### **RE: Response to October 13 Adequacy Review, Glen Johnson No 1 Permit M-1982-044**

**Responses to Division of Mining Reclamation and Safety (DRMS) Adequacy Review of Letter Dated**

**October 13, 2023**

## **Glen Johnson Site 1**

Exhibit Map E  
Showing Existing Site with Improvements  
Glen Johnson Site #1

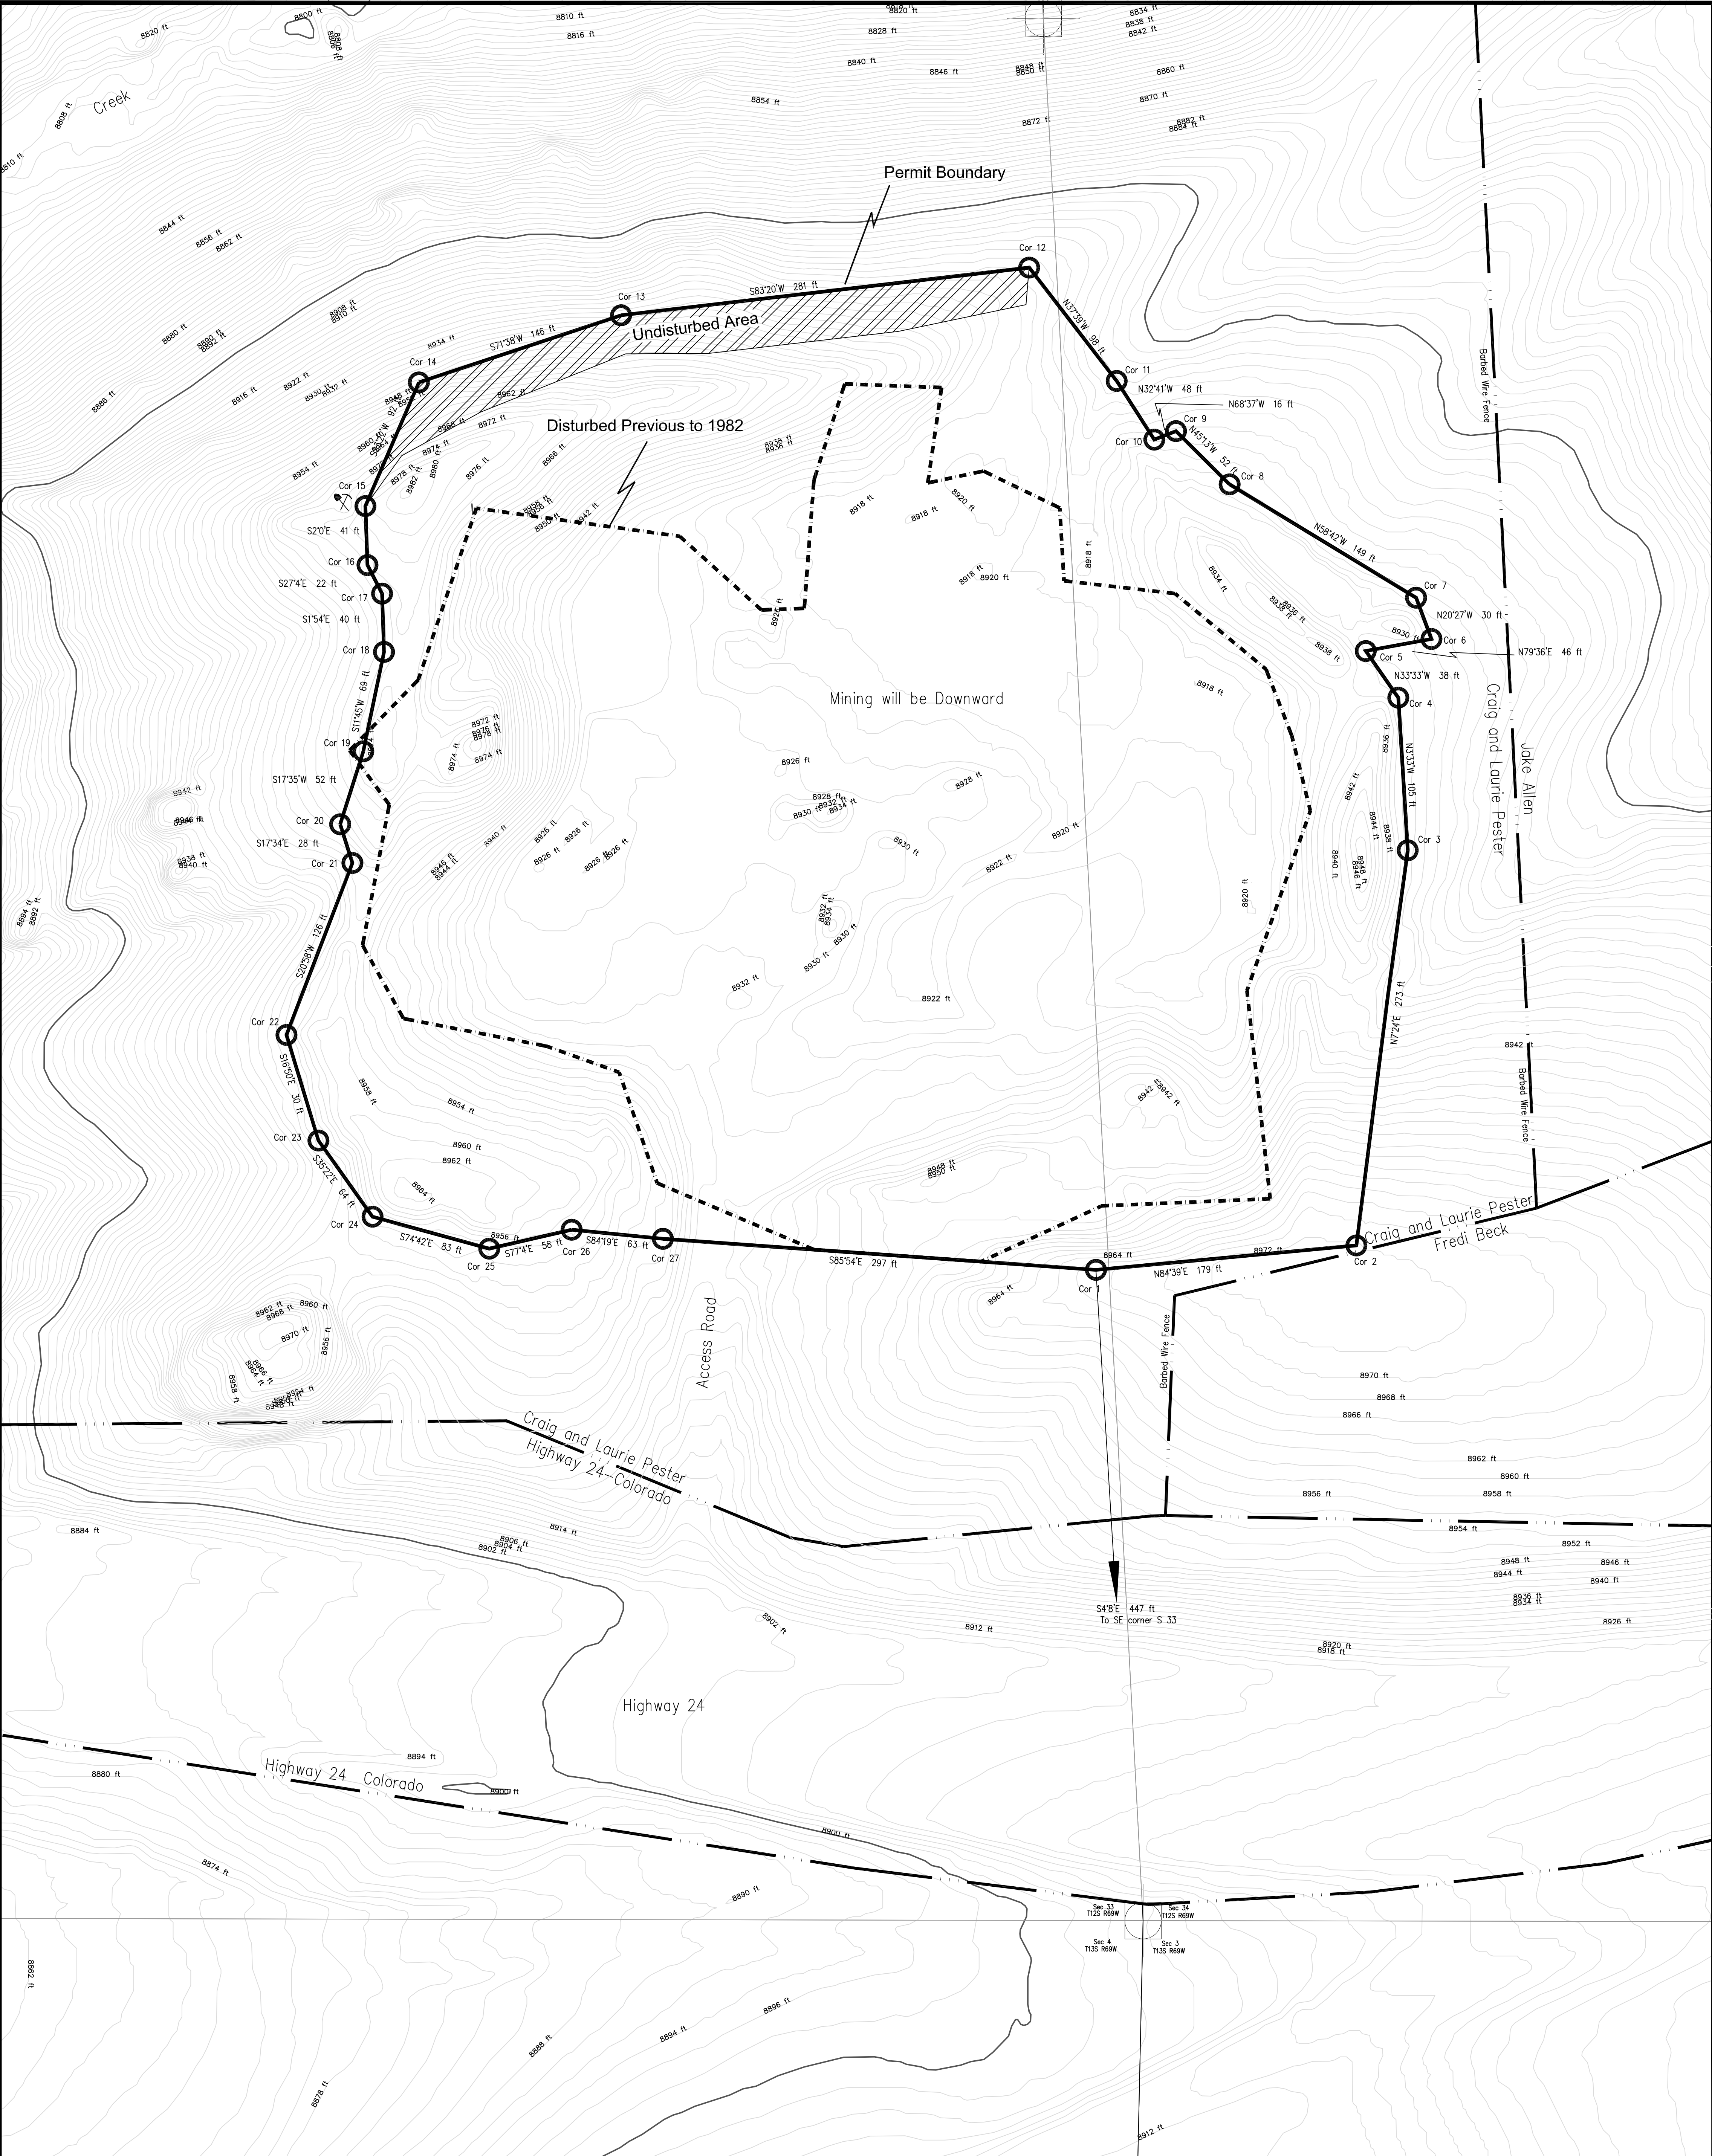
**Comment 5 Within Exhibit B, you have stated there are no structures within 200 feet of the permit area. Upon review of the Exhibit E maps, the eastern parcel boundary is located within approximately 60 feet of the proposed permit boundary and the southern parcel boundary is located within approximately 120 feet of the proposed permit boundary. Please verify there are no a fence lines along these boundaries. In the event a fence exists, please update Exhibit B and Exhibit E as required by Rule 6.3.2(b) and Rule 6.3.5(2)(b). In the event you are not the sole owner of these structures, please update Exhibit L as required by Rule 6.3.12.**

**Comment 14 As required by Rule 6.3.5(2)(c) and (d), please update the Exhibit E Map to outline and label all major surface features to be used in connection with the proposed operation and indicate the direction that construction material extraction will process.**

Response: There is barbed wire fencing along the eastern and southern property boundaries which is owned and maintained by Mr. Pester. Both exhibits have been updated.

Response: There are no existing surface features that will be used in connection with mining and as the currently disturbed area nearly exactly matches the future disturbed area, there is little alternative but to mine downward. The words "Mining will be Downward" have been added to Exhibit E map.

Reclamation Plan Map E-1

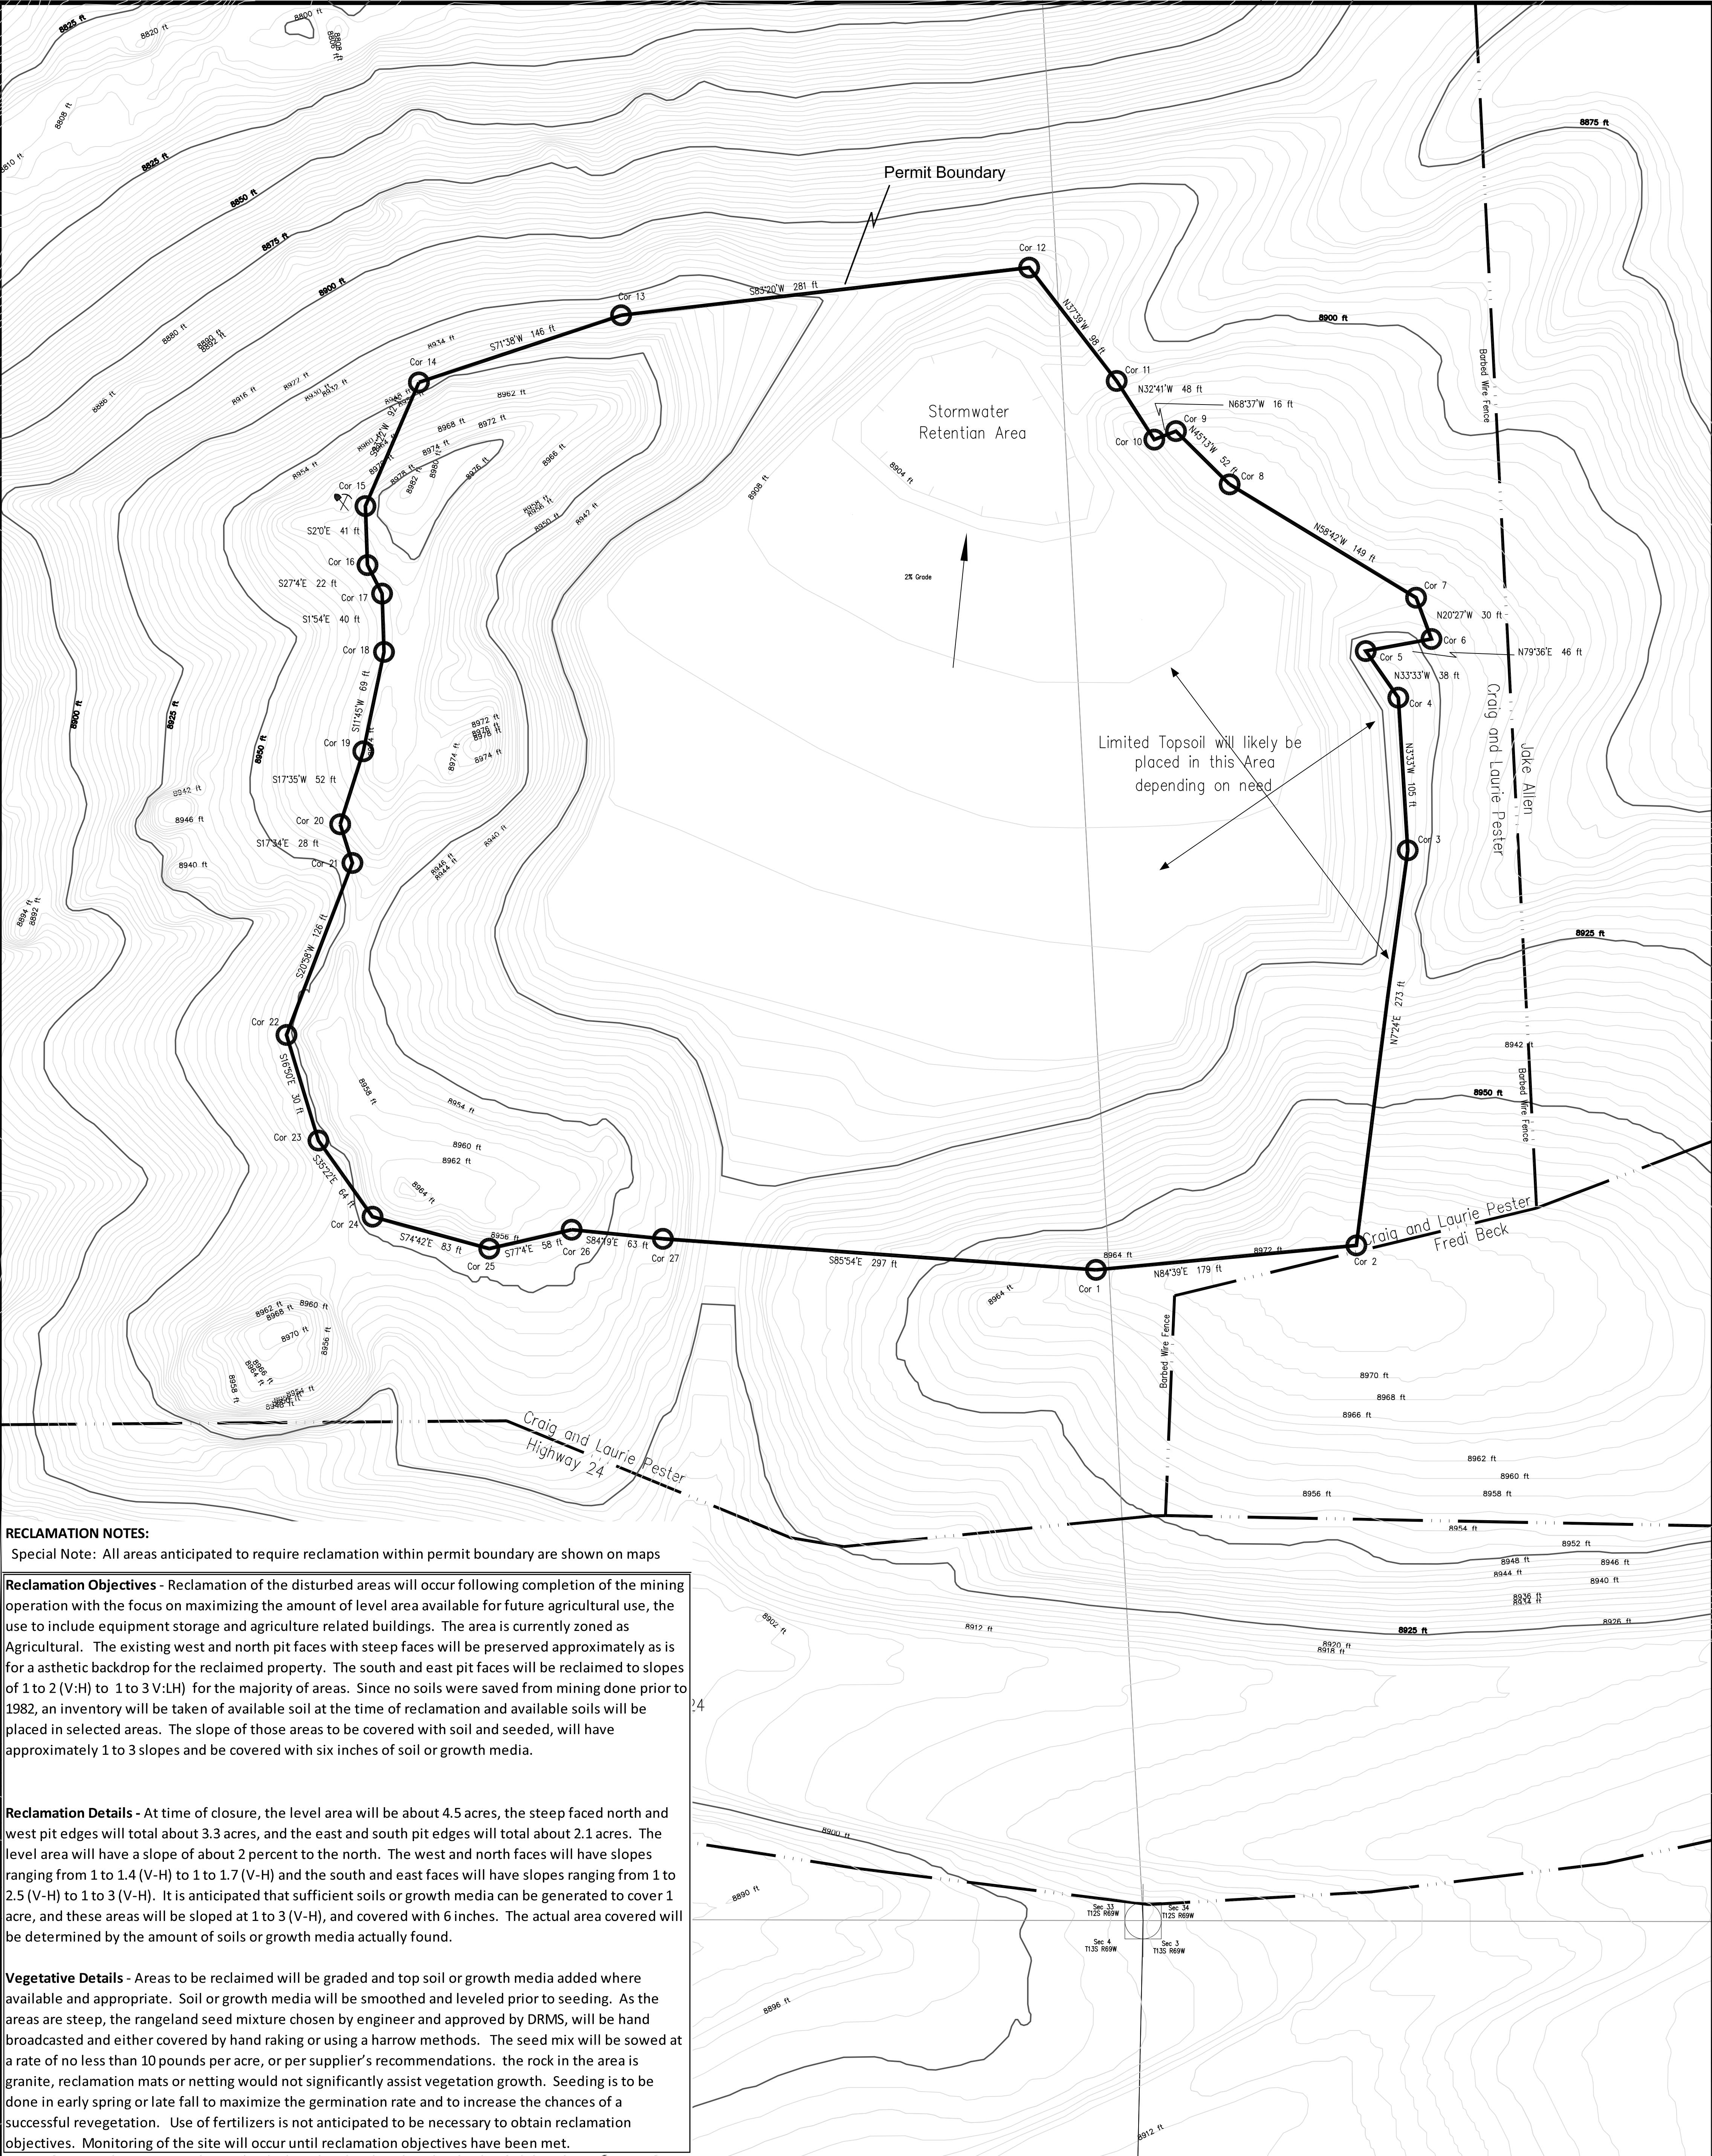
**Comment 7** Within Exhibit C, you have stated that precipitation has been, and will continue to be retained, on-site and will infiltrate into the permeable subsurface. Upon review of the existing and proposed final reclamation topography contours provided on the Exhibit E and E-1 Map, there appears to be a low spot in the north-northeast portion of the permit area which could allow storm water to leave the disturbance area. Please describe the measures that will be taken to ensure storm water is retained on-site and off-site sedimentation is prevented.

**Comment 15 In accordance with Rule 6.3.5(2)(b), please update the Exhibit E-1 Map to show the area where topsoil and seeding will occur versus the area where vegetation will not be established.**

Response: Thank you for reminding us of this inadvertent drafting error. The design includes a shallow temporary holding pond area having a depth of three feet located at the northeast corner of the leveled area. Based on historical data, approximately 5 acres of surface was disturbed previous to the development of regulations regarding storm water runoff. As a result, sufficient storage is now required to retain the runoff generated from the subsequent 4.9 acres of disturbance that occurred after regulations were adopted. The 10-year 24 hour storm event is shown to produce 2.47 inches of total precipitation, and the SCS Runoff Curve Value (CN) for disturbed ground is 52. Using these values, the calculated runoff generated from the 4.9 acres is 22,700 cubic feet of water, and the pond volume is designed to contain 30,000 cubic feet with a holding capacity of one hundred and thirty percent of this calculated runoff volume. The shallow design will allow the storm surge to be contained, and the porous granite bottom will allow rapid drainage.

Response: At this time, sufficient material exists on the site to place a topsoil to cover less than one acre of the total 9.9 acres that will be disturbed. The design calls for the north, and center to northwest portion of the pit to remain as decorative exposed rock. On the west and southwest sides of the pit, the walls are partially covered with grass and pine trees, and as can be seen on Exhibit Map E-1 are approximately currently in the same configuration as they will be when reclamation is completed. The south face has some material located along it which may or may not be suitable for growth media. At this time it is not possible to accurately determine where the existing stockpiled soil might be best put to use. Based on current information, it will most likely best be used either near its present location along the east side of the pit, or distributed along the southeastern edge on the level bottom. The notation has been added to Exhibit E-1.
